N63R Map Thermostat Faults

This Service Information bulletin replaces SI B12 13 16 **dated July 2016**

G12 (750i sedan)	 With the N63R engine
------------------	--

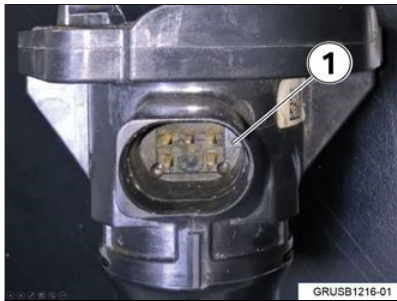
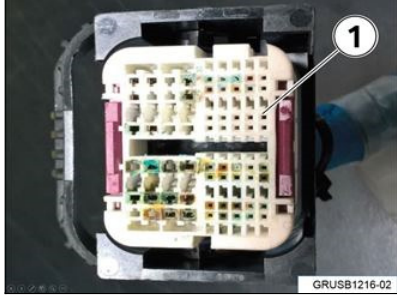
1. Remove the connector for the map thermostat (1) and check
--	--

GRUSB1216-01	for coolant. Is coolant present in the engine wiring sensor harness for cylinders 1-4? YES - replace the map sensor thermostat (PN 11 53 8 602 282) and the sensor harness (PN 12 51 8 654 414). Go to step 2. NO - continue diagnosis by performing the associated test plan in ISTA/D.
 GRUSB1216-02	2. Check the wiring harness connector at the DME for coolant (1). Is there any coolant at the DME harness connector? YES – Continue to step 3. NO – Repair is complete.
 GRUSB1216-03	3. Check the DME and PDM connector sockets for coolant contamination (1). Is there any contamination at the electrical connectors for the DME or PDM? YES- Submit a TC case to the TC DME group for DME and PDM parts replacement approval NO- Repair is complete.
 GRUSB1117-05	UPDATE! Check the index number (1) on the new thermostat (PN 11 53 8 602 282). Improved service parts have an index number UPDATE! “05” or later. Do not install a thermostat with an index lower than “05”.
